Report to the Future Melbourne Committee

Ministerial Planning Referral: ID-2020-5
850-868 Lorimer Street, Port Melbourne

16 February 2021

2.1 Ground Floor & Public Realm - Stage 1 & 2

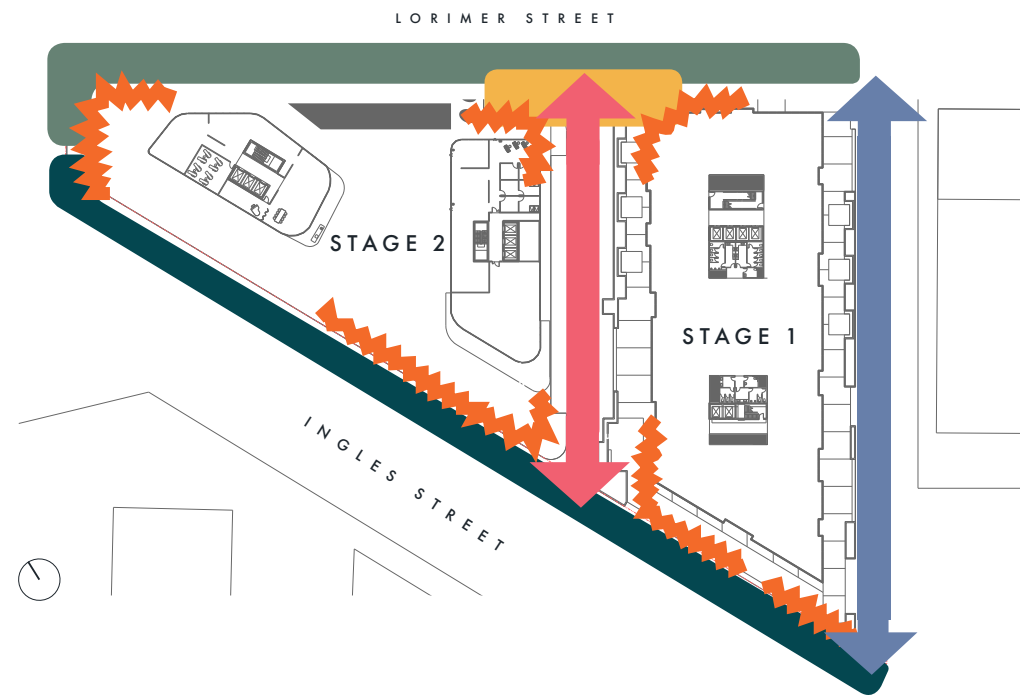
- *Figure 2.1, a Functional Layout, identifies a 'Green Plaza' at the northern end of the vehicle access but a 'green' element is not evident in the subsequent schematic design plans and images. Have opportunities for 'greening' been identified at this location?*
